Project No. 07516-42-02
February 9, 2022

Subject: ADDENDUM GEOTECHNICAL REPORT AND
RESPONSE TO CITY OF SAN DIEGO REVIEW COMMENTS
NAKANO
SAN DIEGO, CALIFORNIA

GEOLOGIC MAP
NAKANO
CHULA VISTA, CALIFORNIA

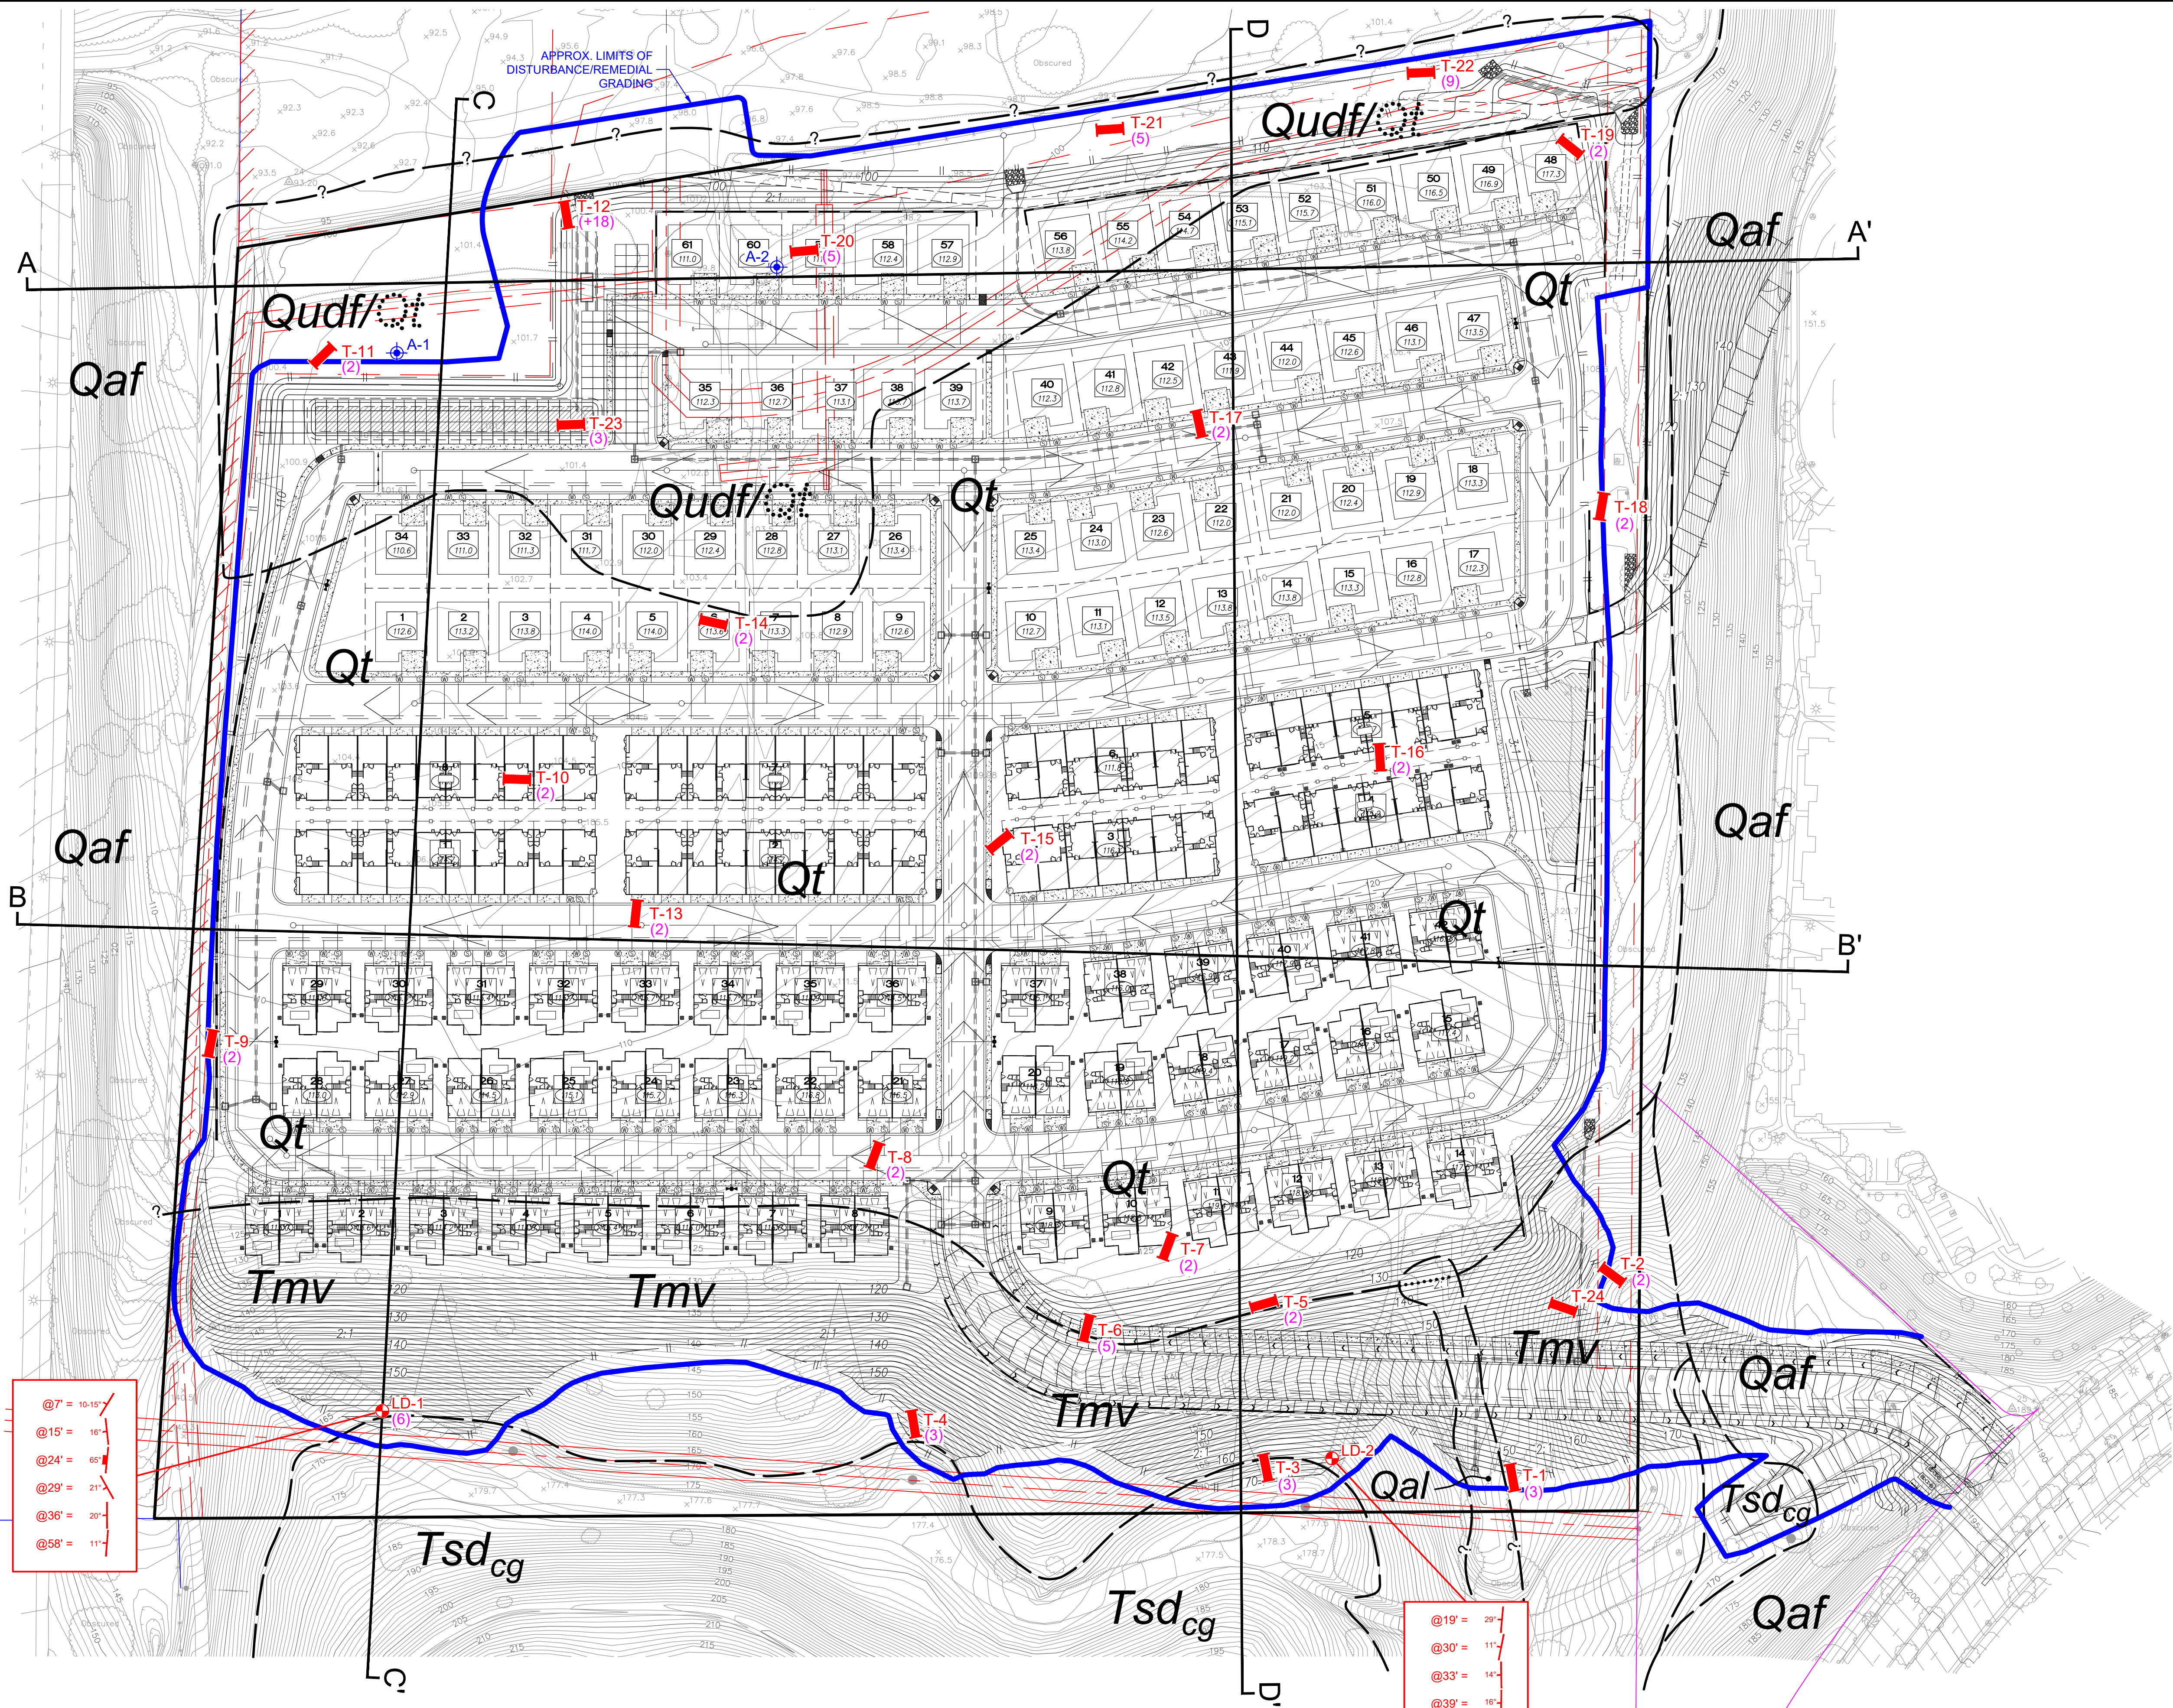
Issue 4: *Clarify if the southeastern corner of the subject property is underlain by a landslide (geologic hazard zone 22) with a rupture surface deeper than the extent explored in the test pits.*

Response: The southeast corner of the property is not underlain by a landslide. A second large diameter boring (LD-2) was drilled to a depth of 70 feet at the east end of the proposed cut slope (Figure 1 and appended boring log). The boring bottom elevation is approximately 16 feet below proposed pad grade at toe of slope. Observations made during downhole logging show similar geologic conditions to those observed in LD-1, i.e., a massive to poorly bedded very fine-grained silty sandstone dipping approximately 14 degrees due west. There are no slide planes, bedding plane shears, or other geologic features indicative of landsliding present in LD-1 or LD-2.

GEOLOGIC CROSS-SECTION C-C'
SCALE: 1" = 60' (Vert. = Horiz.)

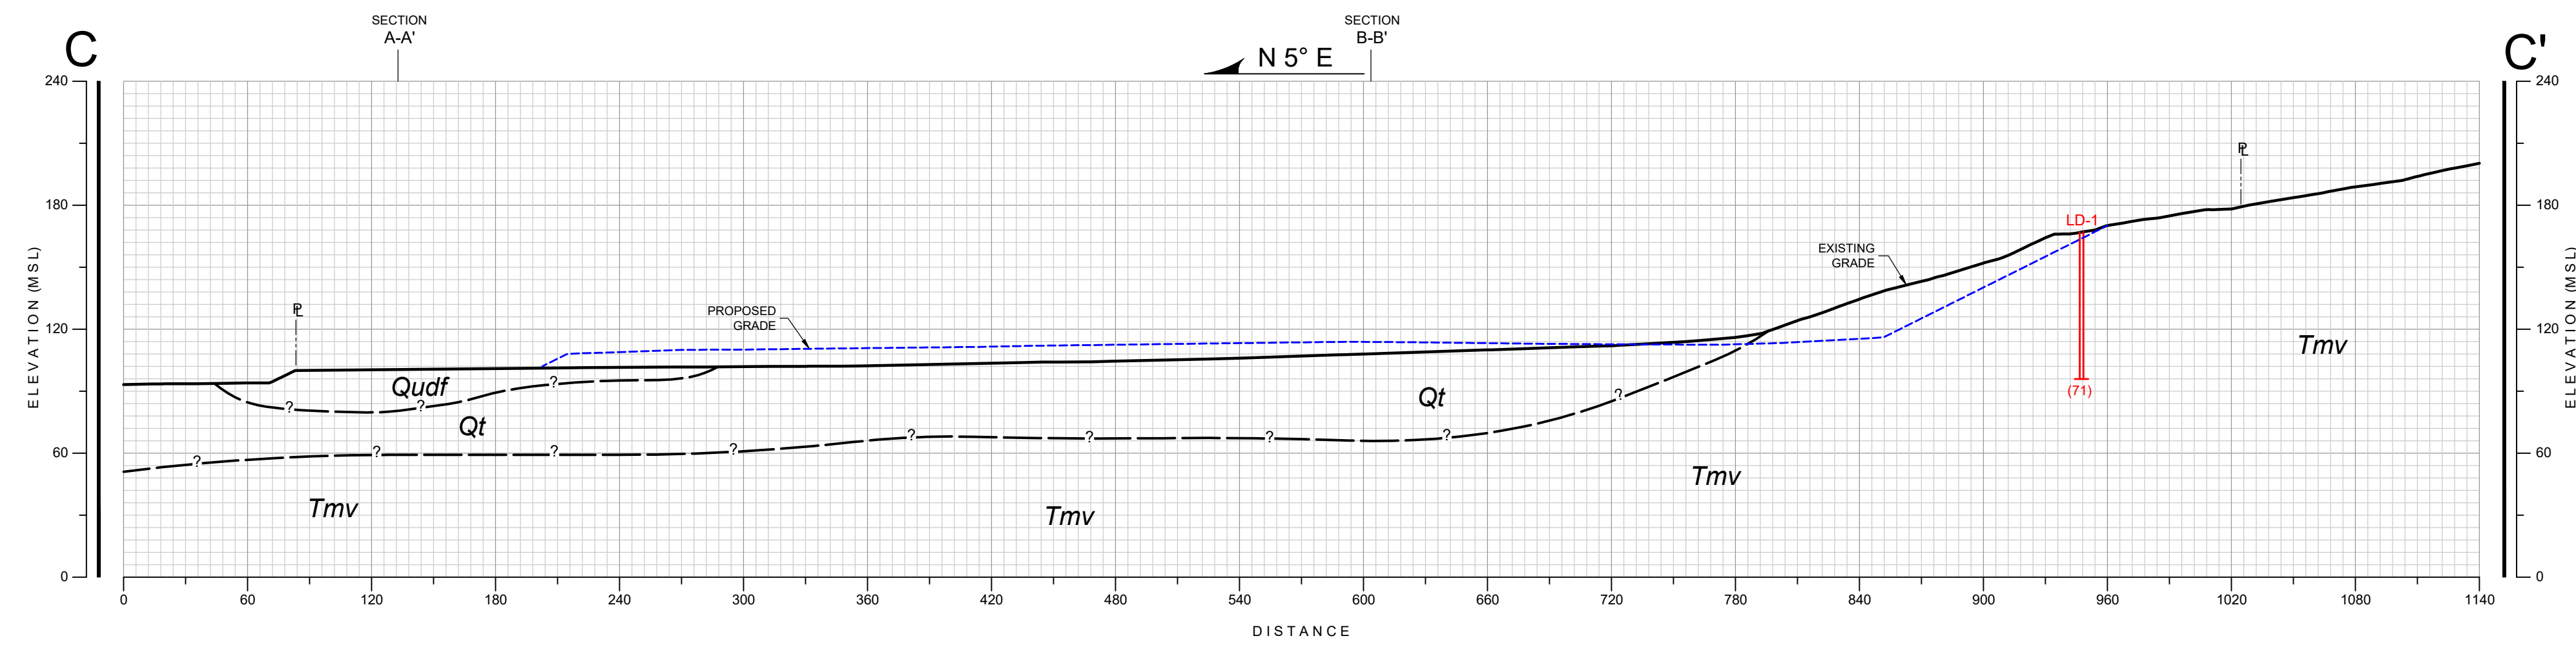
Issue 5: *Per the State's Guidelines for Evaluating Seismic Hazards in California (2008), the commonly accepted factor of safety for slopes is >1.1 for dynamic loads. The projects' geotechnical consultant should demonstrate that the site will comply with this standard following project completion.*

Response: We performed a seismic slope stability analysis for cross sections C-C' and D-D' in accordance with *Recommended Procedures for Implementation of DMG Special Publication 117: Guidelines for Analyzing and Mitigating Landslide Hazards in California*, prepared by the Southern California Earthquake Center (SCEC), dated June 2002.

The seismic slope stability analysis was performed using an unweighted acceleration of 0.16g, corresponding to a 10 percent probability of exceedance in 50 years. In addition, a deaggregation analysis was performed on the 0.16g value for the site. A modal magnitude and modal distance of 6.1 and 11.1 kilometers, respectively, were used for the analysis.

Using the parameters discussed herein, an equivalent site acceleration, k_{EQ} , of approximately 0.1g was calculated (see Figure 4). Using this k_{EQ} , we get a factor of safety of 1.86 for Section C-C' (see Figure 5) and 2.2 for Section D-D' (see Figure 6). A slope is considered acceptable by the screening analysis if the calculated factor of safety is greater than 1.0 using k_{EQ} ; therefore, the slopes pass the screening analysis for seismic slope stability.

Figure 5

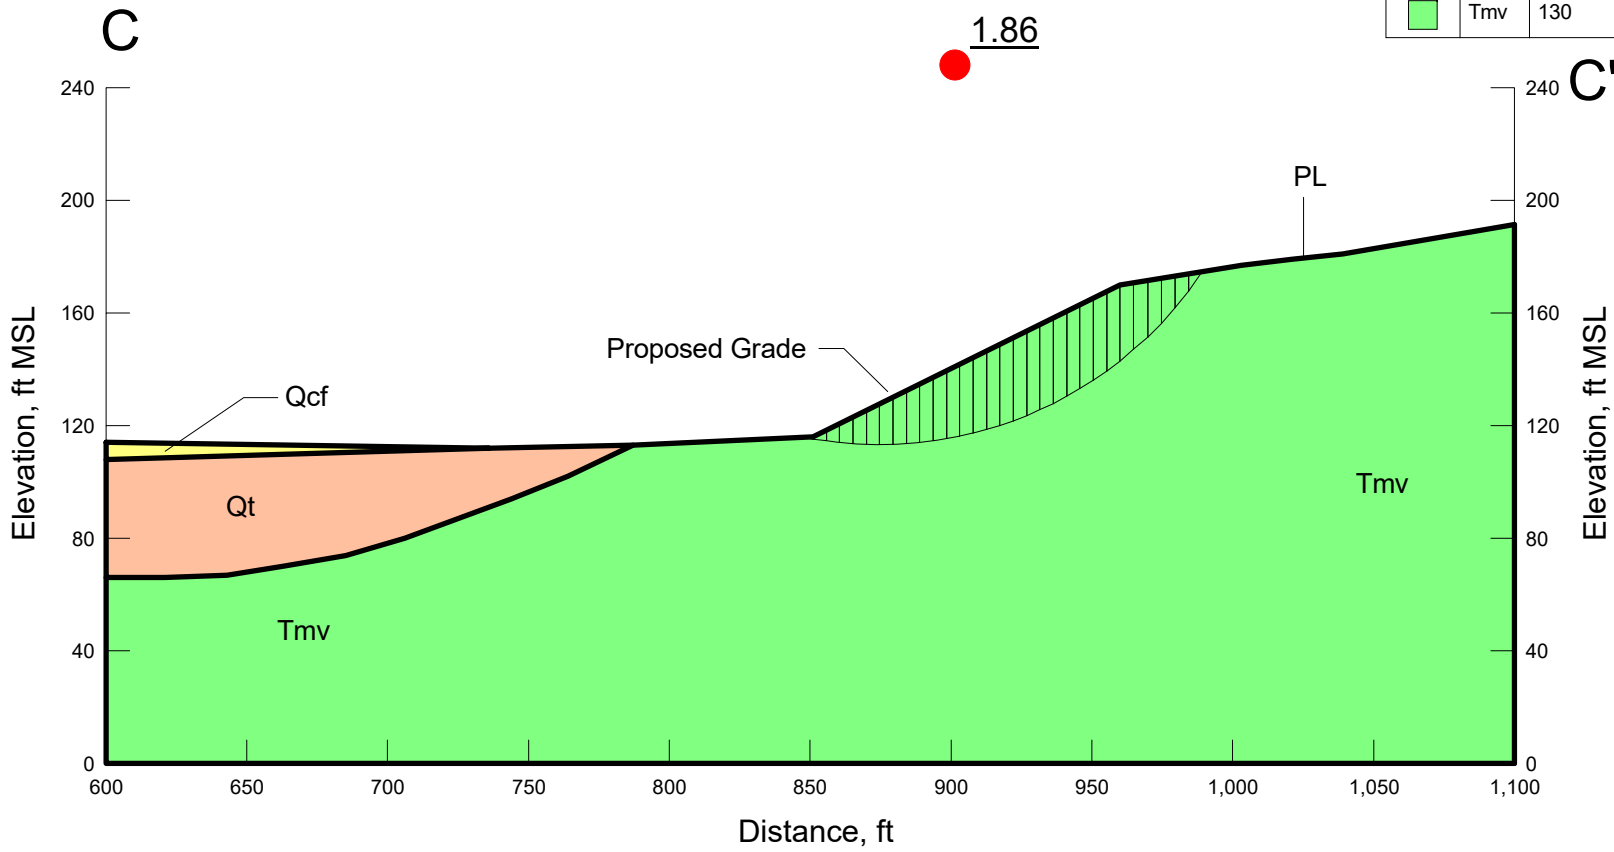
Issue 6: *Provide the Slope stability calculations.*
